**Re 308/2021/DA-SL – Seniors Housing Julius Road, Rosemeadow**

## Matters raised by Council in RFI 6 October 2021

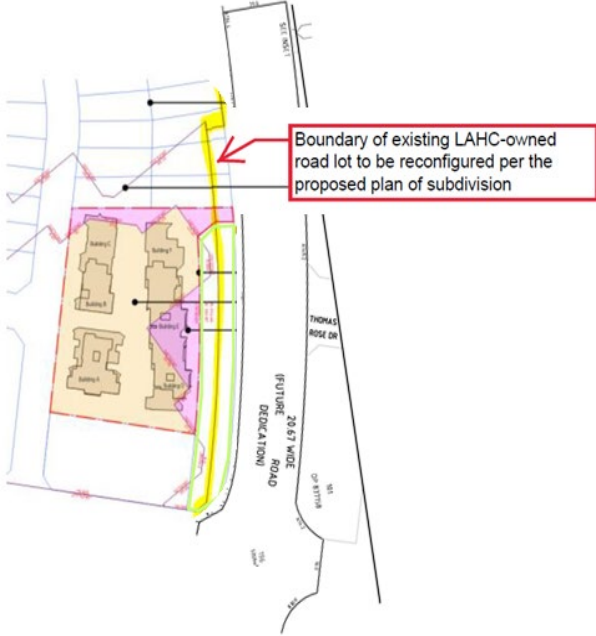
32.	The Statement of Environmental Effects provides that the proposed floor plan layouts include generous balconies and private open spaces which comply with these and the ADG guidelines minimum size and proportions. Numerous dwellings do not comply with the minimum width dimension or the minimum size requirements.	<p>Areas indicated on floor plans.</p> <p>In confirming extent of non-compliances with balconies:</p> <p>1) Three ground floor balconies (Units 10, 13 and 16) fail to meet the required area of 15sqm. In these cases, balconies are elevated above the site level due to cross fall of site, have no privacy implications and are well buffered by deep landscape planting. The areas could be extended to comply, but at the expense of beneficial deep soil landscape area.</p>

Item No	Council Comment	Response
		<p>2) 11 ground floor balconies (Units 1, 4, 5, 6, 7, 8, 11, 12, 14, 15, 17) have greater than the required area, but do not comply with the 15sqm of space with 3m minimum dimension clause. In these cases, layouts are functional, furnishable and well buffered by landscape planting. The area of the terraces could be extended to comply, but at the expense of beneficial landscape plantings in common areas, and hence, certainly maintained.</p> <p>On balance it is our opinion that the ground floor terraces are optimal as designed because they allow for practical use of the outdoor space and allow for maximised common planting areas, which are in turn beneficial in providing a buffer between common walkways and private open space.</p>

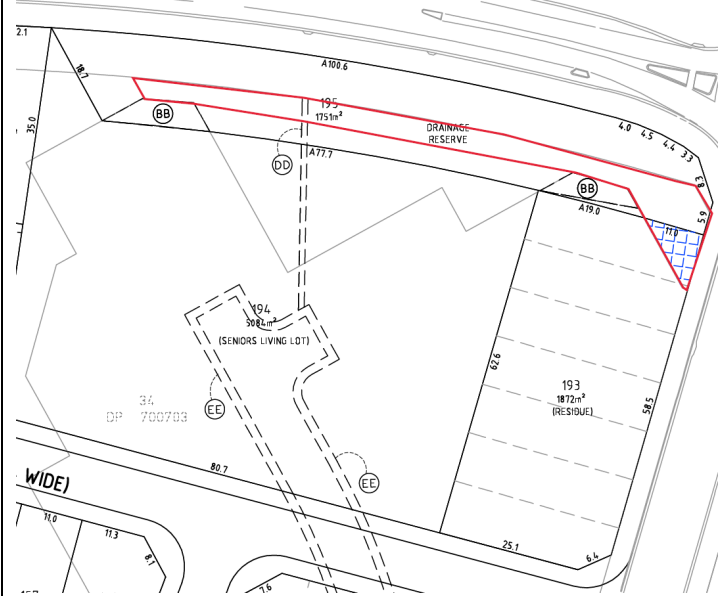
40.	Privacy concerns are also raised in relation to Units with balconies facing the future town house development being Units 02, 03, 17, 20, 19, 36, 35, 34.	Units 2 and 3 are at ground level with terraces oriented to the north. They are 10.5 metres from the boundary and boundary planting is proposed in a deep soil zone. No privacy issue. Units 17 is at ground level with the terrace oriented to the north. It is 10.5 metres from the southern boundary and boundary planting is proposed in a deep soil zone. No privacy issue. Units 19 and 20 (level 1) have their primary outdoor space oriented away from the future townhouses with smaller balconies off the bedrooms on the southern façade. The

Item No	Council Comment	Response
		<p>balconies are 9.3 metres from the southern boundary and boundary planting is proposed in a deep soil zone. Balconies are partially screened. The combined effect of setback and screen planting result in an acceptable privacy impact..</p> <p>Unit 34 balcony (level 1) is setback 6.8 metres from southern boundary and boundary planting is proposed in a deep soil zone. The combined effect of setback and screen planting result in an acceptable privacy impact.</p> <p>Units 35 and 35 (level 2) have their primary outdoor space oriented away from the future townhouses with smaller balconies off the bedrooms on the southern façade. The balconies are 9.3 metres from the southern boundary and boundary planting is proposed in a deep soil zone. Balconies are partially screened. The combined effect of setback and screen planting result in an acceptable privacy impact.</p>
